Re: Response to Transportation Peer Review

Proposed Residential Development - Athens Street

Stow, Massachusetts

Vanasse & Associates, Inc. (VAI) is providing responses to the comments that were raised in the October 18, 2022 Transportation Peer Review letter prepared by Green International Affiliates, Inc. (Green) concerning their review of the April 19, 2022 Transportation Impact Assessment (the "April 2022 TIA") that was prepared by VAI in support of the proposed residential community to be located off Athens Street in Stow, Massachusetts (hereafter referred to as the "Project"). Listed below are the comments that were identified by Green in the subject letter followed by our response on behalf of the Project proponent.

Figure 7R

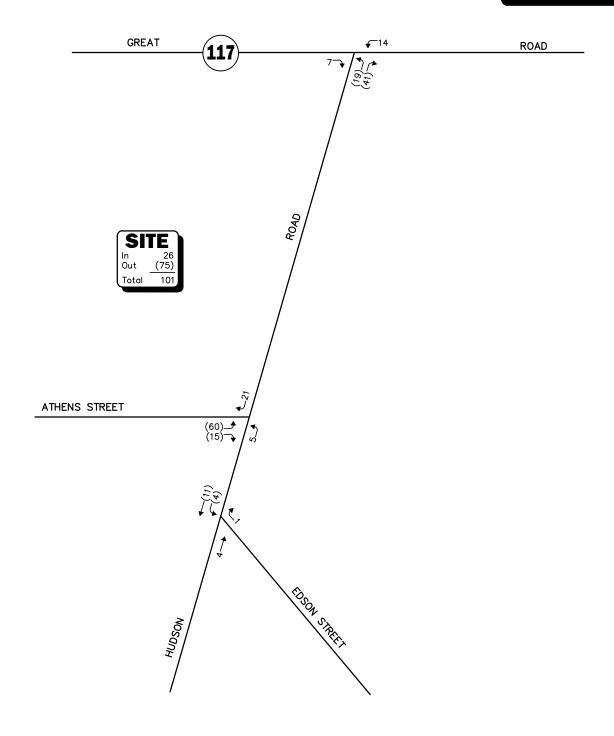
As this community will not have an age restriction, does not include shared amenities or attached dwelling units, and due to ITE's caution, the Applicant should use LUC 210, Single-Family Detached Housing, for all 141 proposed units.

The trip-generation calculations for the Project have been revised using ITE LUC 210, Single-Family (Detached) Housing, the results of which are summarized in Table 3R and reflect a slight reduction in the number of proposed housing units from 141 to 140. Figures 7R and 8R depict the revised weekday morning and evening peak-hour Projectgenerated trip assignment, with Figures 9R and 10R depicting the revised 2029 Build weekday morning and evening peak-hour traffic volumes.

Sight Distance Plan Hudson Road at Athens Street

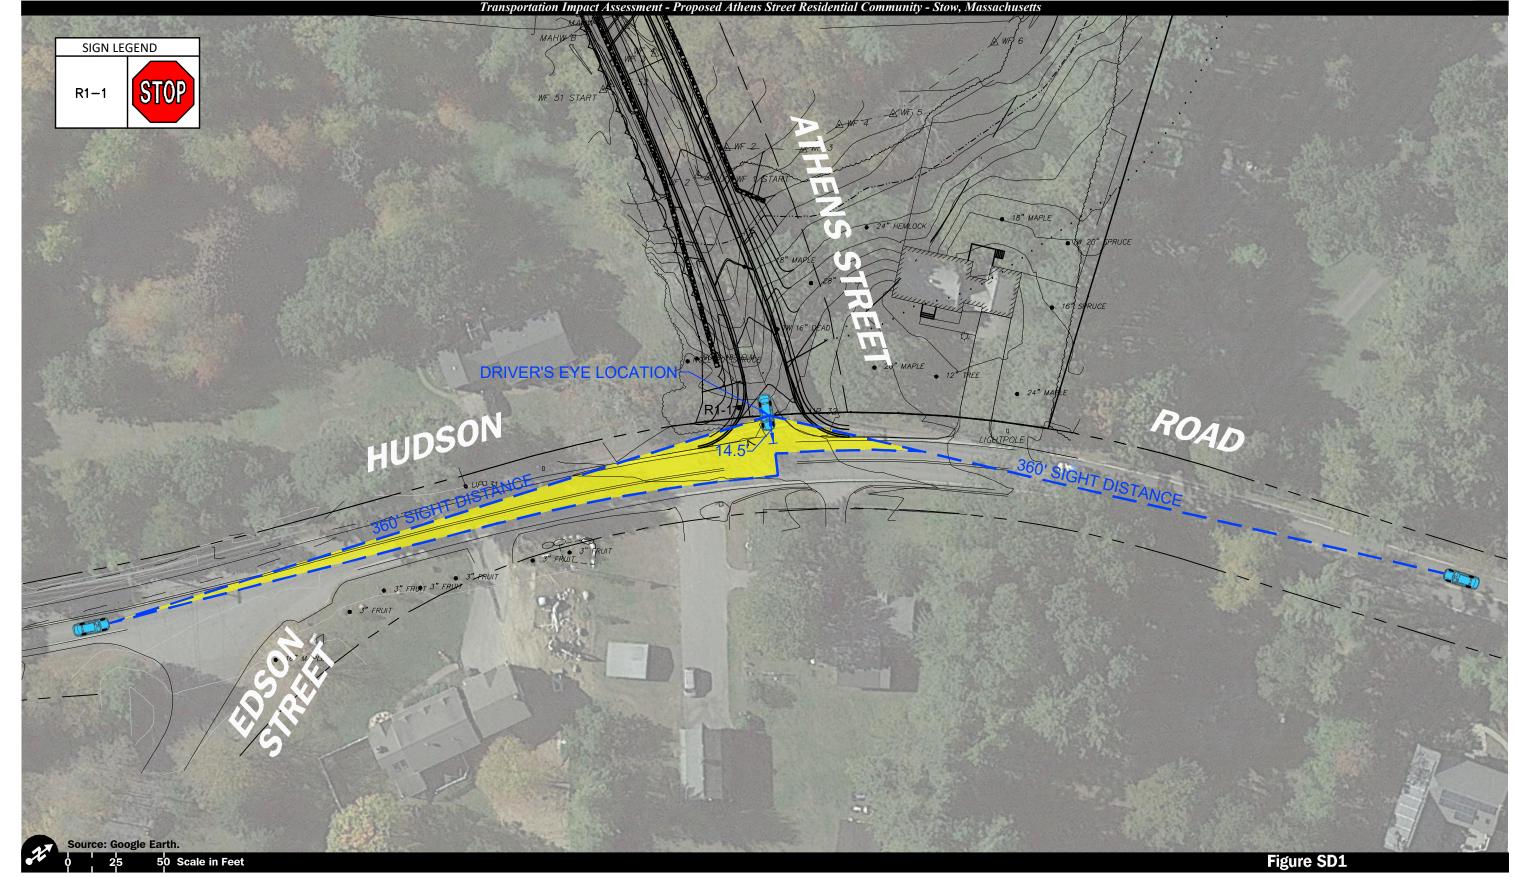
Stopping sight distances (SSD) and intersection sight distances (ISD) were measured at the intersection of Athens Street and Hudson Road. Minimum required sight distances were met in each direction for both stopping sight distance and intersection sight distance. During our site visit, Green confirmed that the minimum sight distances are available; however, vegetation on both corners has the potential to limit sight distance. Please provide a figure showing site triangles that the Applicant will commit to keeping clear of vegetation.

A sight triangle plan has been prepared for the intersection of Athens Street/Hudson Road intersection and is attached.

Conceptual Improvement Plan Hudson Road at Edson Street

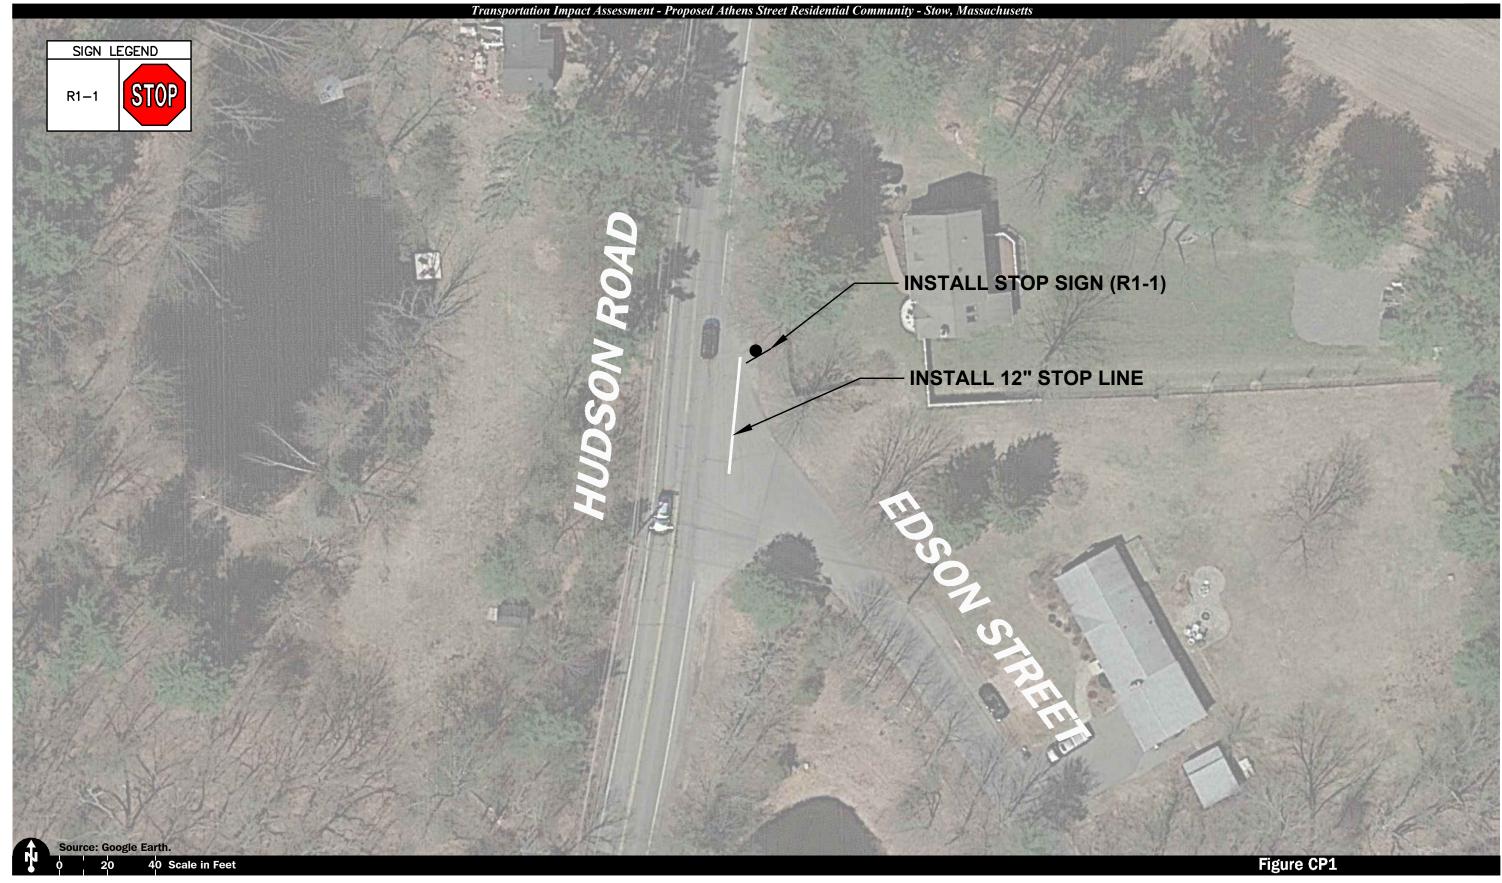
Comment 12: The Applicant will install a STOP sign and STOP line on the Edson Street approach to

Hudson Road. Please provide a conceptual layout of the locations of the STOP sign and

STOP line for review.

Response: A conceptual improvement plan depicting the recommended STOP-sign and STOP-line

placement on the Edson Street approach to Hudson Road is attached.
